**Rio Grande LNG Project**  
*Final Environmental Impact Statement*  
*Volume III, Part 4*

**Rio Grande LNG, LLC and Rio Bravo Pipeline Company, LLC**

**April 2019**  
**Docket Nos. CP16-454-000, CP16-455-000**  
**FERC/EIS-0287F**

COMMENTS ON THE DRAFT ENVIRONMENTAL IMPACT STATEMENT FOR THE  
PROPOSED RIO GRANDE LNG TERMINAL AND RIO BRAVO PIPELINE

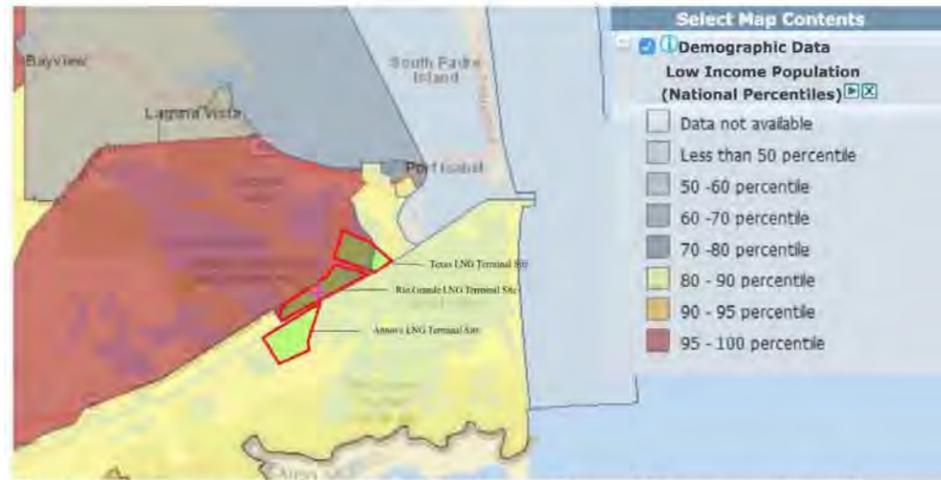
and low-income communities.<sup>15</sup> The DEIS notes that the blocks closest to the LNG Terminal are “environmental justice populations.”<sup>16</sup> Cameron County is a majority-minority county, with non-White people making up 91.1% of the population.<sup>17</sup> As the DEIS acknowledges, the Project would be located in the “poorest metro area ... in the country.”<sup>18</sup> 87.5% of students served by Port Isabel Independent School District (Port Isabel ISD) are economically disadvantaged, and 37.8% of students in Port Isabel ISD schools are English Language Learners.<sup>19</sup>

DEIS, Figure 4.9.3-1.

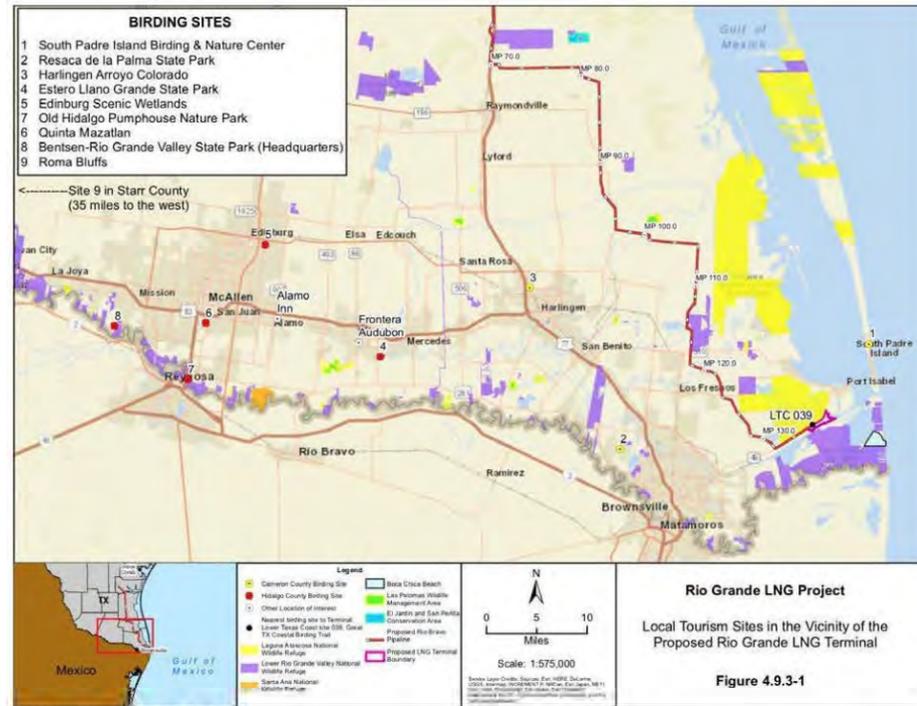
The DEIS does not provide any evaluation of how noise and visual impacts will impact tourism. It acknowledges that the project may alter “visitation patterns,” but does not address what these visitation patterns might look like. Not to mention, this treatment fails to account for the motivations behind nature tourism, which is steeped in admiration for nature that is or perceived to be undisturbed. *Without any evidentiary support*, the DEIS posits that the project will not affect the gross number of tourists that visit the area.
